SUMMARY OF AMENDMENTS

GREYSTAR

APPROVED - SECOND FLOOR PLAN PL002 REV P02

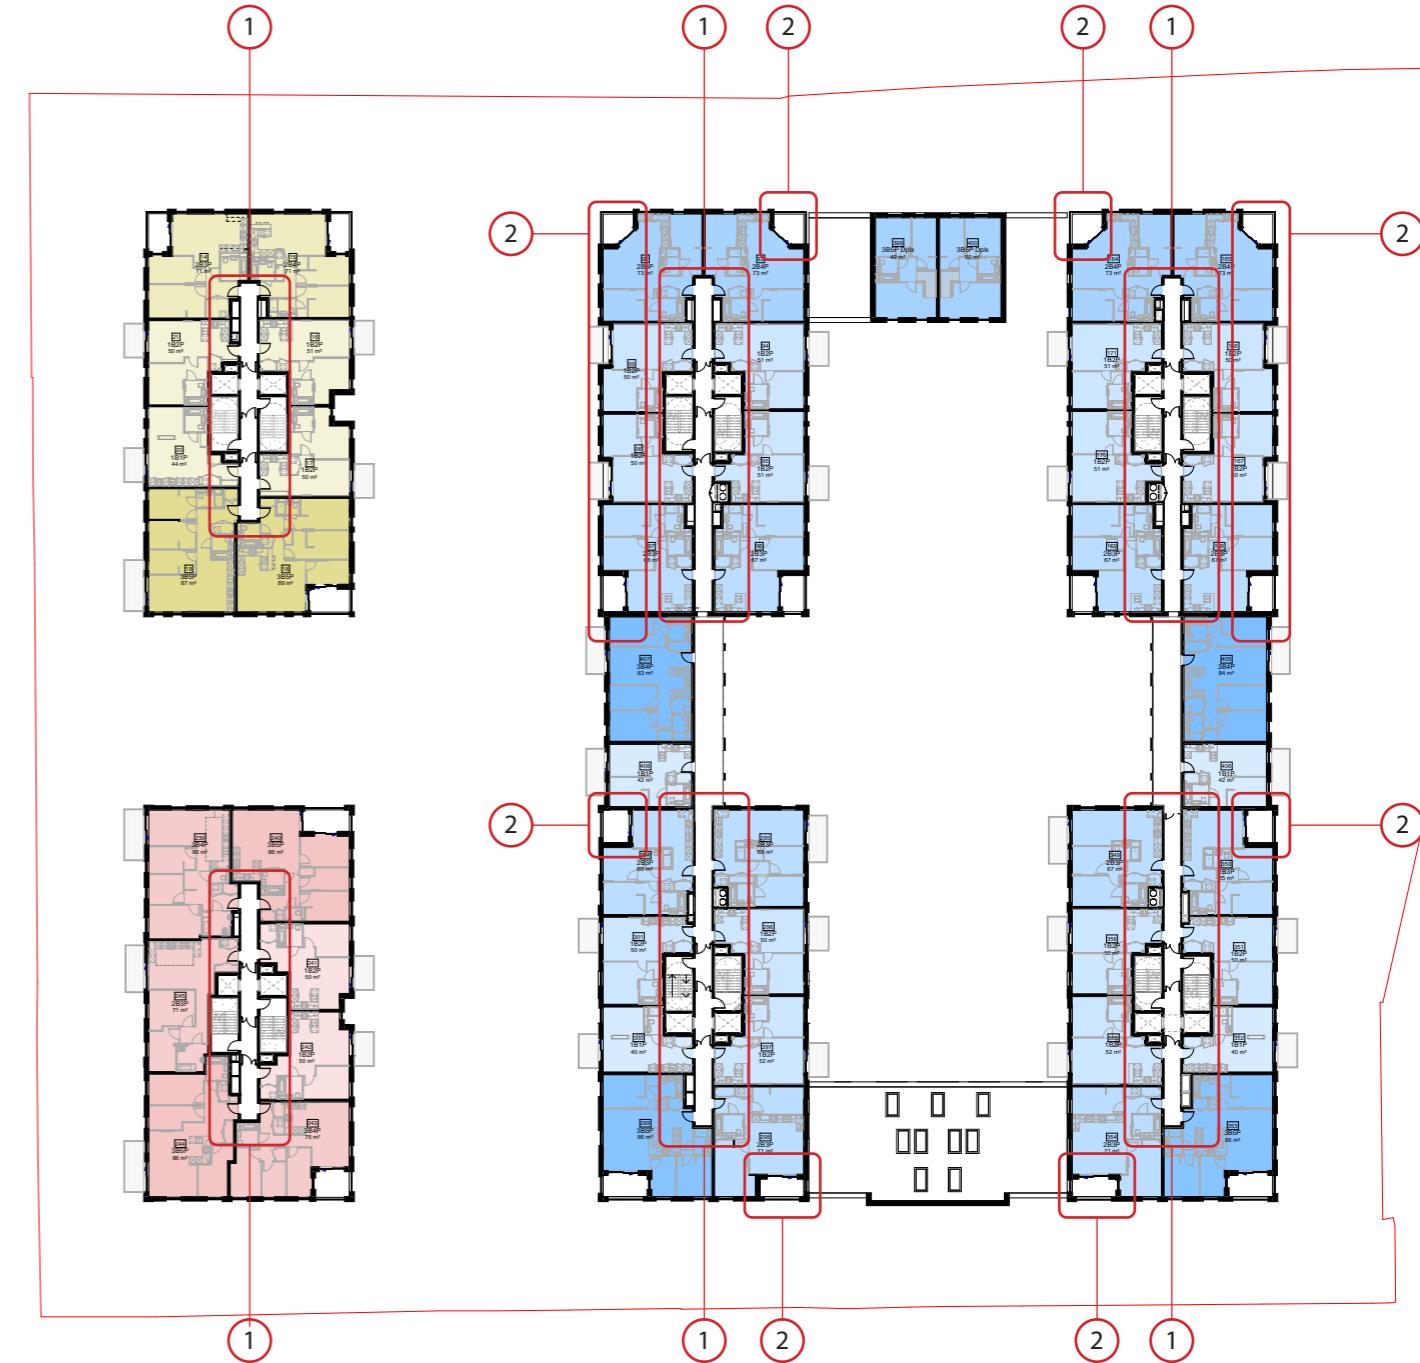
1. Second escape stair added to all cores to provide a secondary means of escape for all residents in the event of a fire. Adjacent homes, risers etc all adjusted to suit.
2. Nominal changes to balconies and facade to ensure that internal flat layouts retain compliance with future fire regulations and ensure escape past hob distances are reduced where possible as advised by JGA Fire.

- Note - overall change in occupancy is required to allow for the additional stairs to be added. Generally this is done by a reduction of 1B2P homes to 1B1P homes. There is no proposed change to the number of family sized dwellings.

APPROVED -THIRD FLOOR PLAN PL003 REV P02

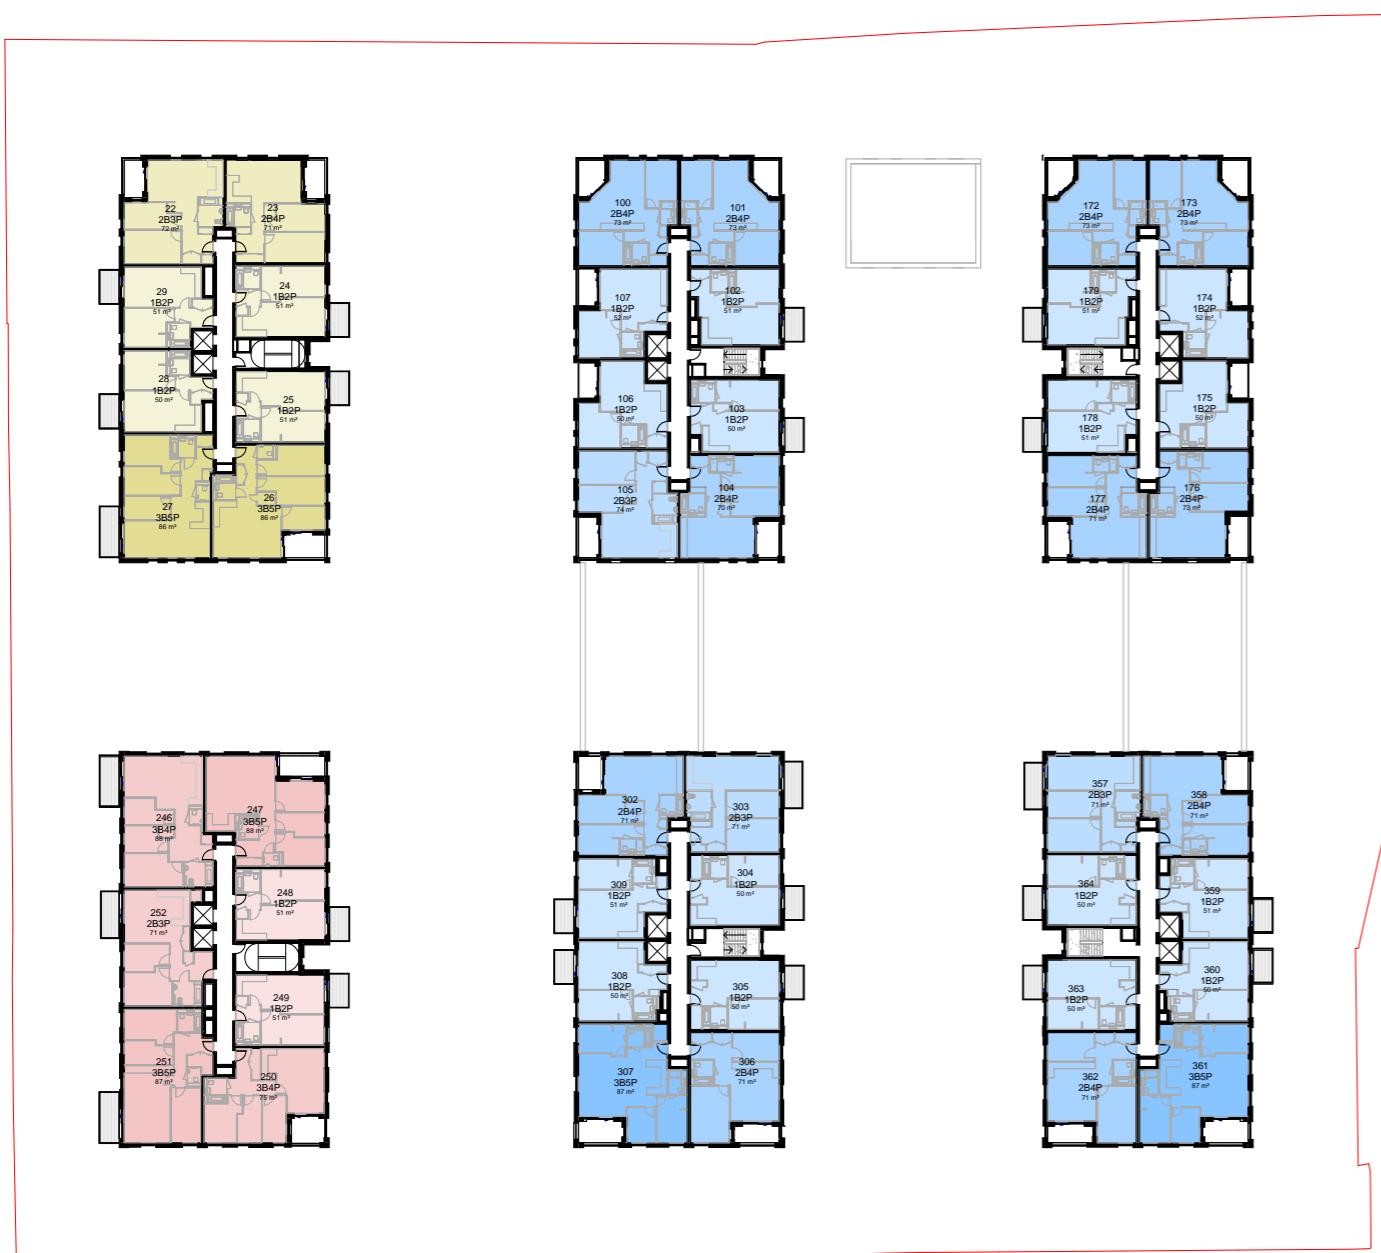
1. Second escape stair added to all cores to provide a secondary means of escape for all residents in the event of a fire. Adjacent homes, risers etc all adjusted to suit.
2. Nominal changes to balconies and facade to ensure that internal flat layouts retain compliance with future fire regulations and ensure escape past hob distances are reduced where possible as advised by JGA Fire.
 - Note - overall change in occupancy is required to allow for the additional stairs to be added. Generally this is done by a reduction of 1B2P homes to 1B1P homes. There is no proposed change to the number of family sized dwellings.

APPROVED -SEVENTH FLOOR PLAN PL007 REV P02

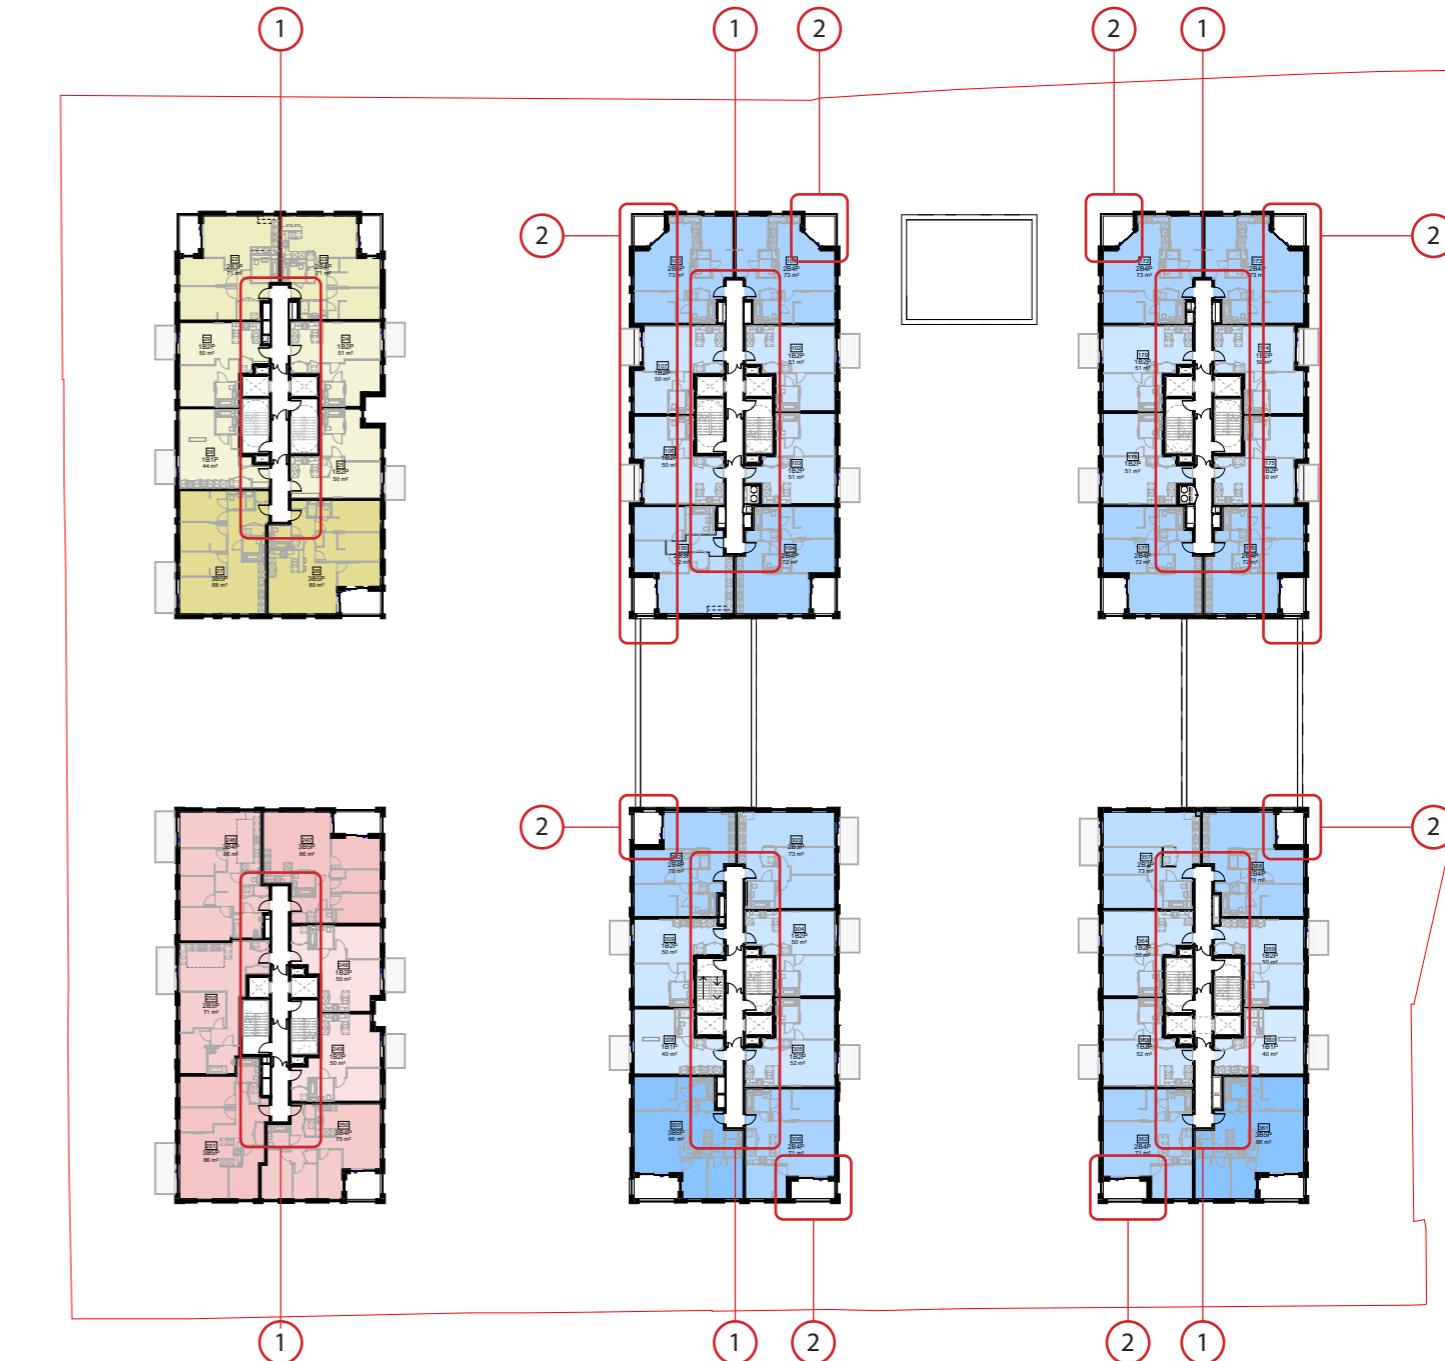
1. Second escape stair added to all cores to provide a secondary means of escape for all residents in the event of a fire. Adjacent homes, risers etc all adjusted to suit.
2. Nominal changes to balconies and facade to ensure that internal flat layouts retain compliance with future fire regulations and ensure escape past hob distances are reduced where possible as advised by JGA Fire.
- Note - overall change in occupancy is required to allow for the additional stairs to be added. Generally this is done by a reduction of 1B2P homes to 1B1P homes. There is no proposed change to the number of family sized dwellings.

APPROVED -EIGHTH FLOOR PLAN PL008 REV P02

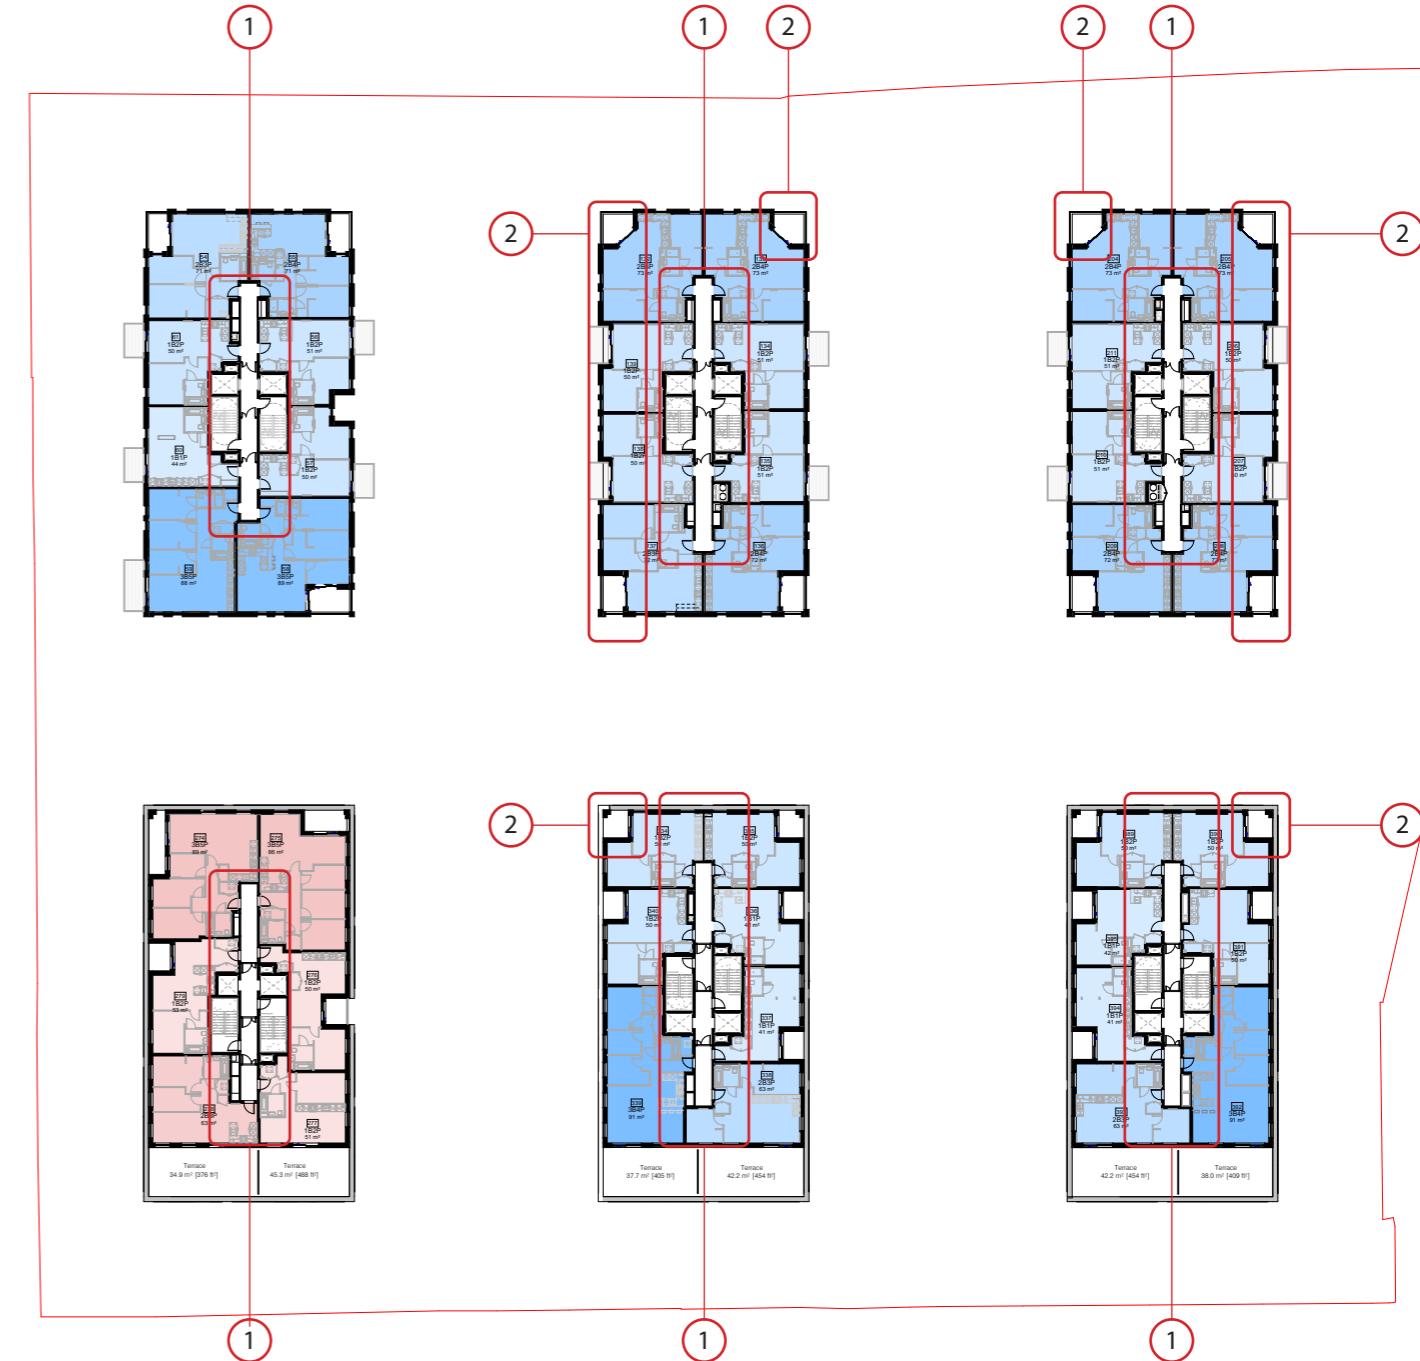
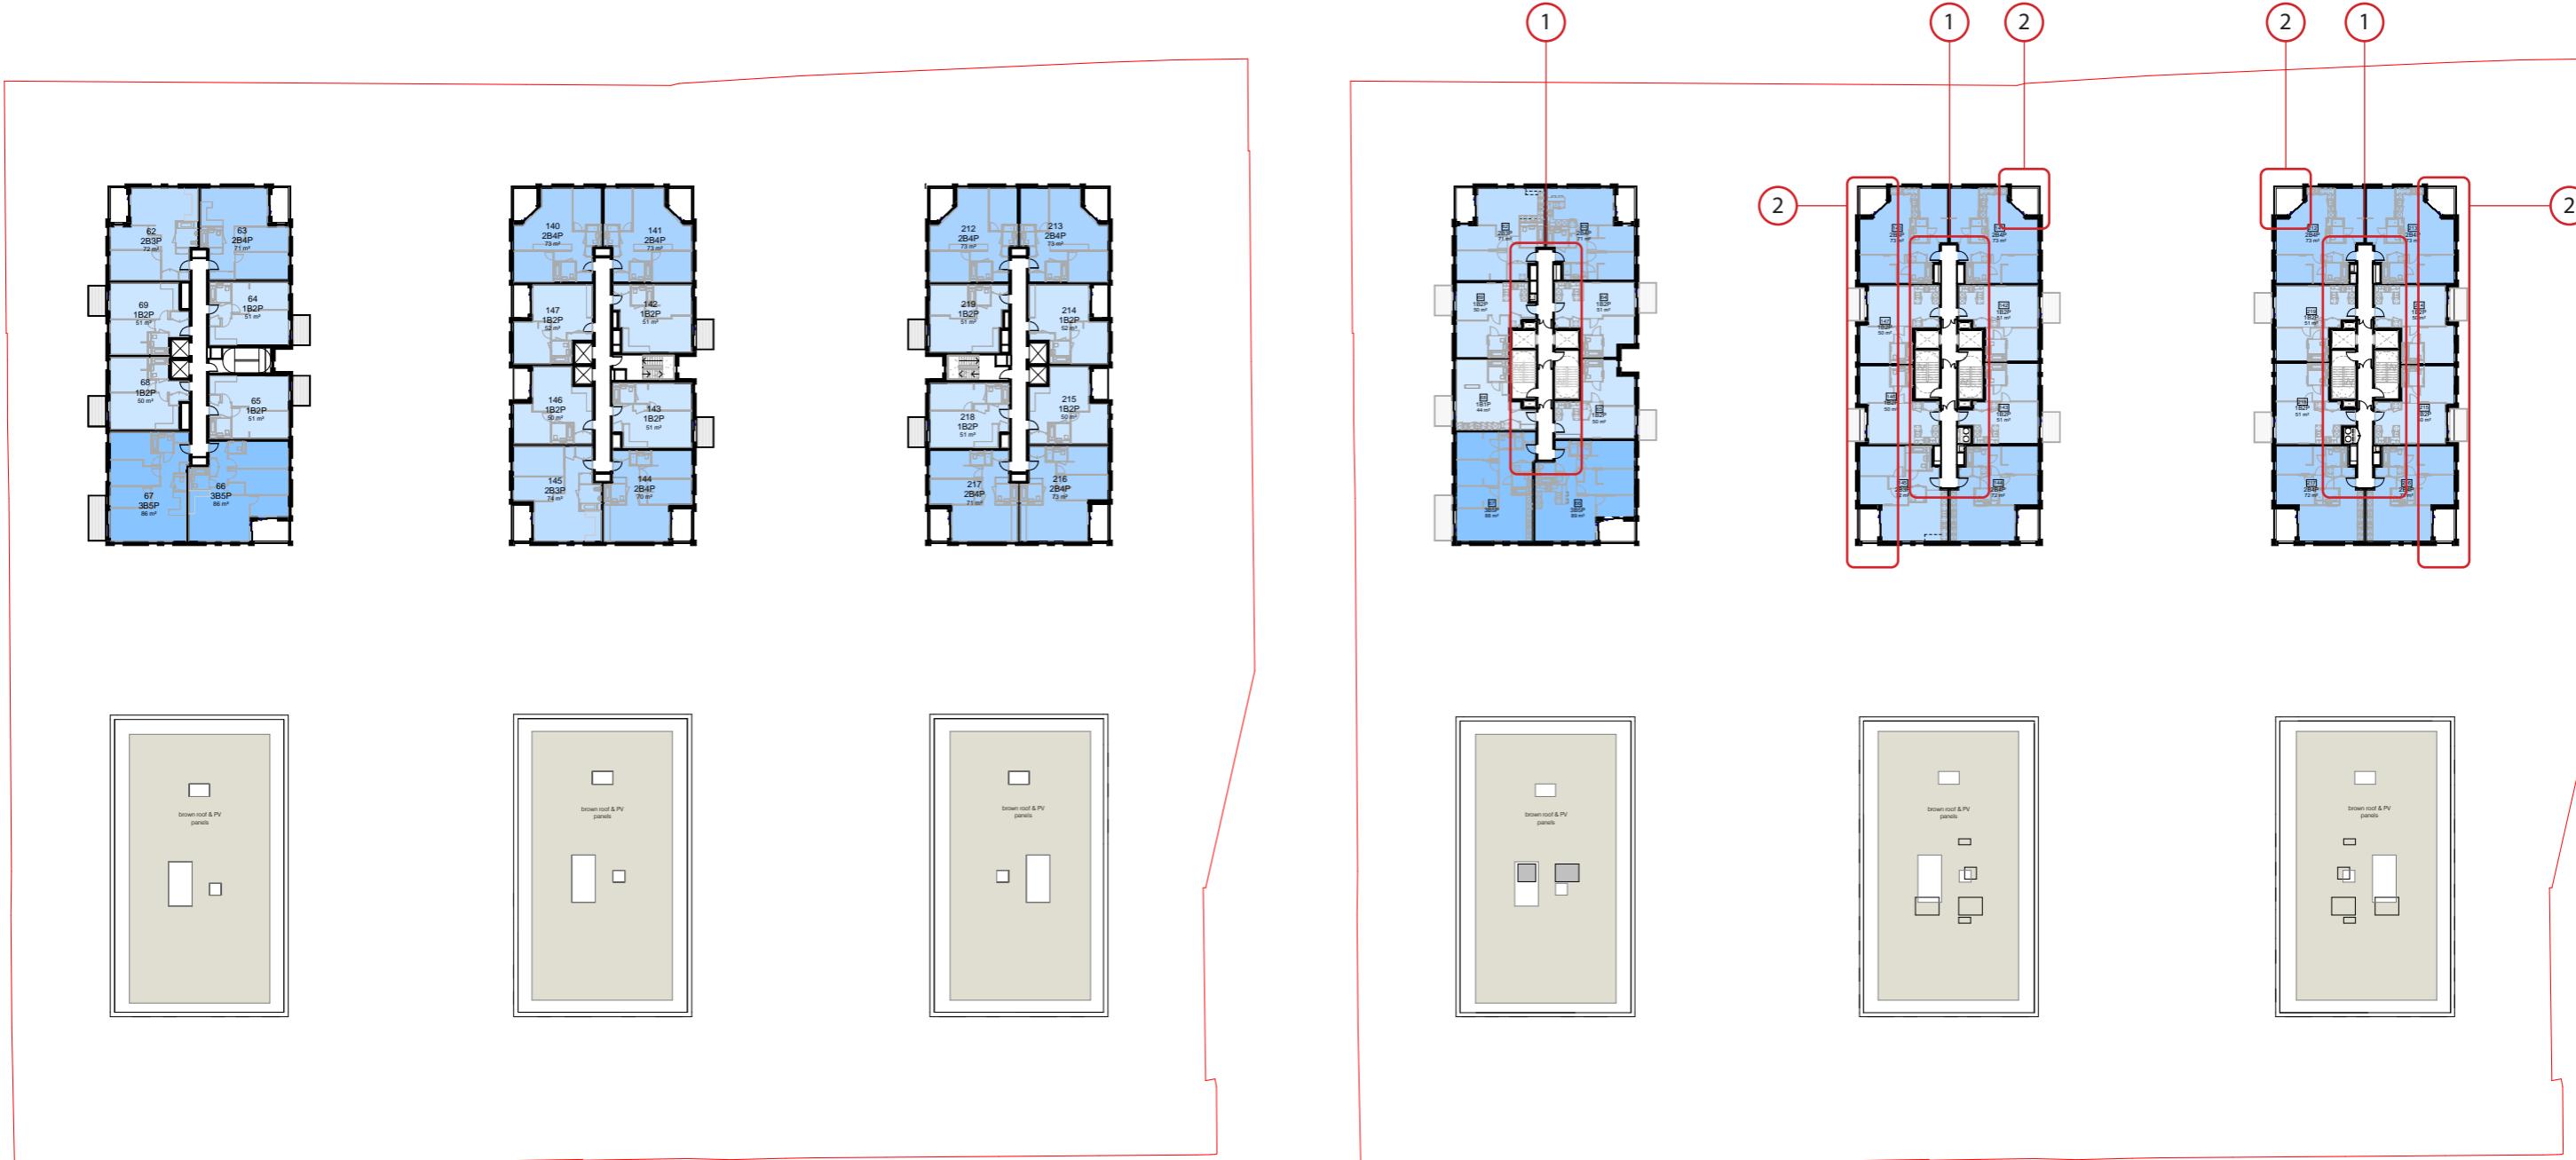
1. Second escape stair added to all cores to provide a secondary means of escape for all residents in the event of a fire. Adjacent homes, risers etc all adjusted to suit.
2. Nominal changes to balconies and facade to ensure that internal flat layouts retain compliance with future fire regulations and ensure escape past hob distances are reduced where possible as advised by JGA Fire.
 - Note - overall change in occupancy is required to allow for the additional stairs to be added. Generally this is done by a reduction of 1B2P homes to 1B1P homes. There is no proposed change to the number of family sized dwellings.
